## New Spark Plug Wire Locations on Distributor Cap

Models	Serial Number Or Year
3.0 TKS and MPI	1A337296 and above

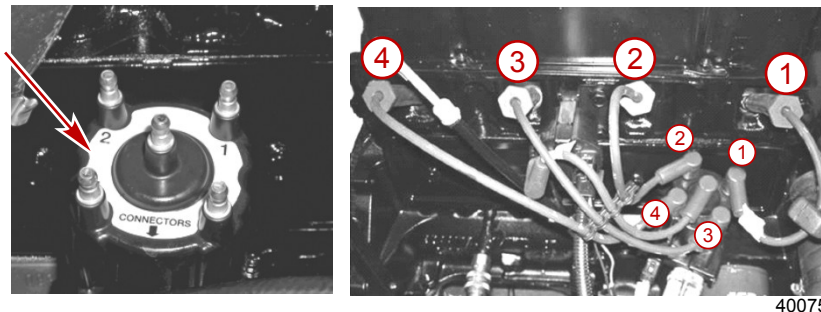
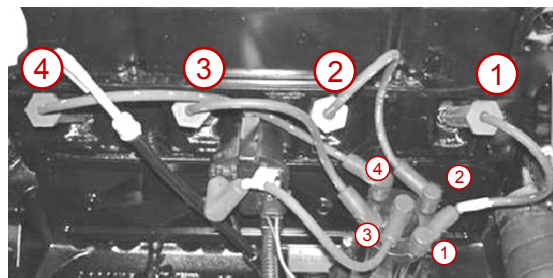
The spark plug wires on the distributor have been relocated. A new decal on the distributor cap notes this change to prevent confusion if using current literature or comparing to prior engines. The engine firing order remains unchanged.

Follow the new decal for spark plug wire locations on engines with serial number 1A337296 and above.

Spark plug wire locations on engines with serial number 1A337295 and below.
